The Commission has issued the enclosed Amendment No. 49 to Facility Operating License No. DPR-58 and Amendment No. 34 to Facility Operating License No. DPR-74 for the Donald C. Cook Nuclear Plant, Unit Nos. 1 and 2, respectively. The amendments consist of changes to the Facility Operating Licenses including changes to the Technical Specifications in response to your application transmitted by letter dated December 10, 1980.

These amendments revise the Technical Specifications and adds certain license conditions for the Category "A" Lessons Learned (NUREG-0578) requirements implemented at the Donald C. Cook Nuclear Plant, Unit Nos. 1 and 2.

AMENDMENT TO FACILITY OPERATING LICENSE

SAFETY EVALUATION BY THE OFFICE OF NUCLEAR REACTOR REGULATION
RELATED TO AMENDMENT NO. 49 TO FACILITY OPERATING LICENSE NO. DPR-58
AND AMENDMENT NO. 34 TO FACILITY OPERATING LICENSE NO. DPR-74
INDIANA AND MICHIGAN ELECTRIC COMPANY
DONALD C. COOK NUCLEAR PLANT UNIT NOS. 1 AND 2
DOCKET NOS. 50-315 AND 50-316

FIGURE 6.2-2 Facility Organization -- Donald C. Cook -- Unit No. 2

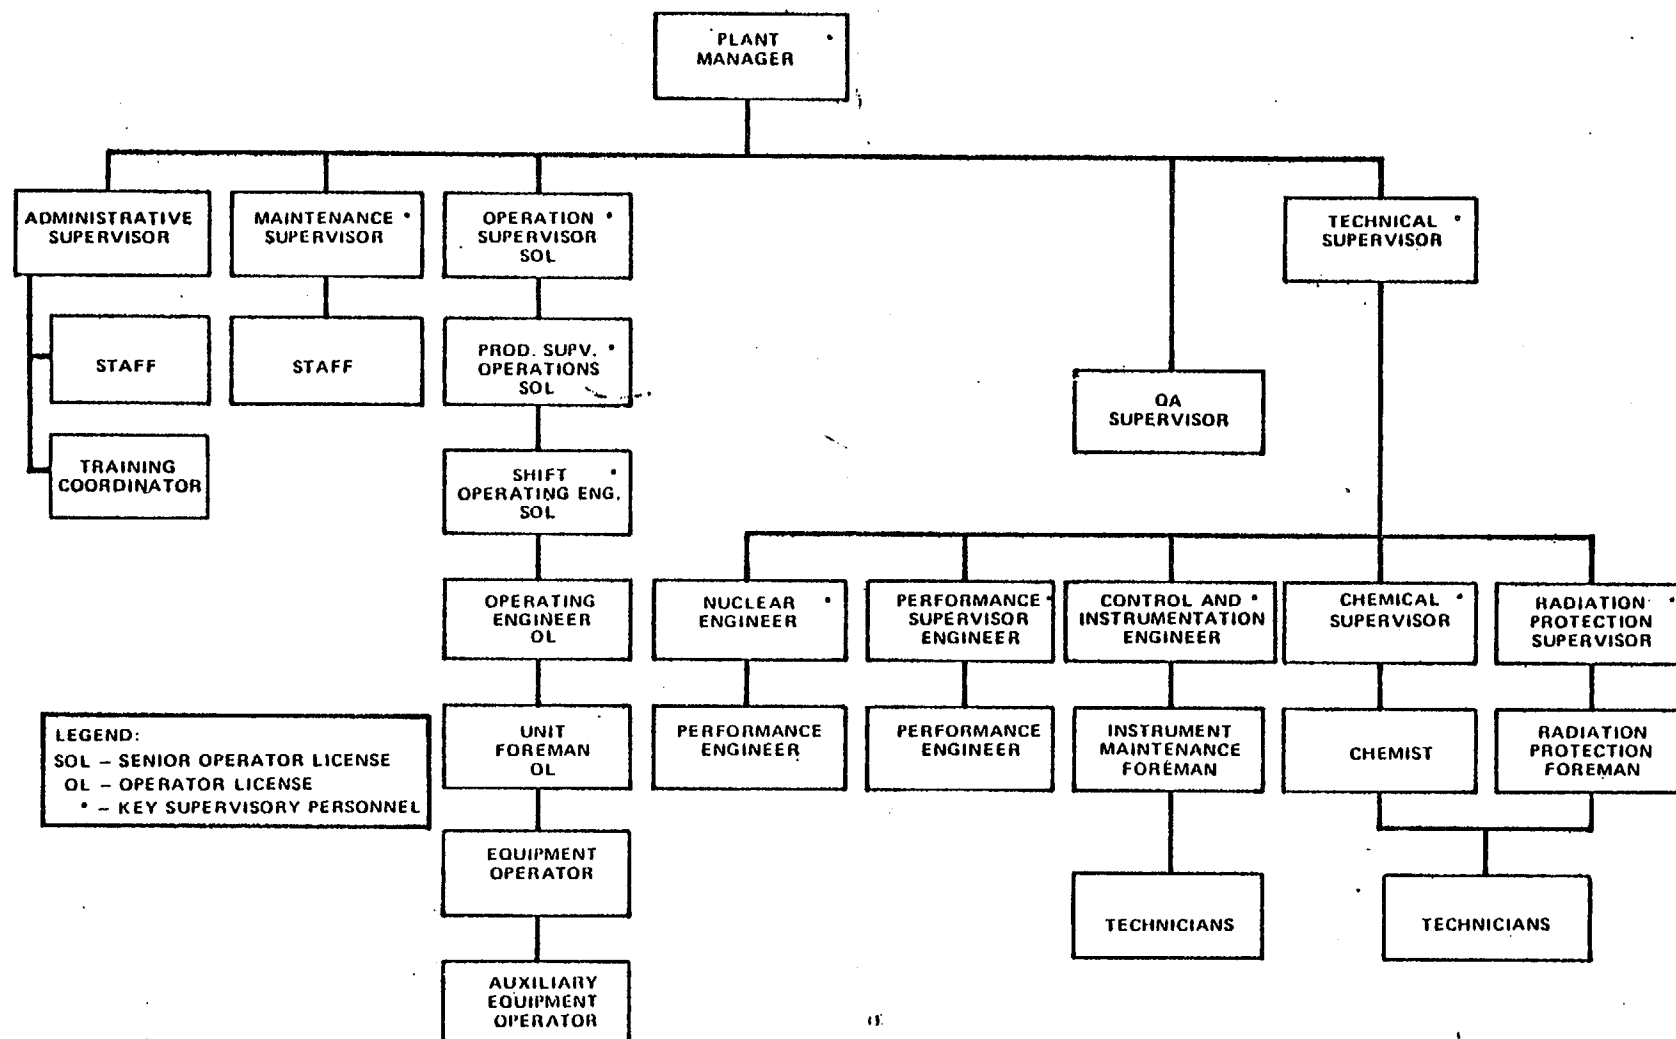
Our request indicated that the TSs related to minimum shift manning should be revised to reflect the augmentation of an STA. The licensee's application would add one STA to each shift to perform the function of accident assessment. The individual performing this function will have at least a bachelor's degree or equivalent in a scientific or engineering discipline with special training in plant design, and response and analysis of the plant for transients and accidents. Part of the STA duties are related to operating experience review function. Based on our review, we find the licensee's submittal to satisfy our requirements and is acceptable.
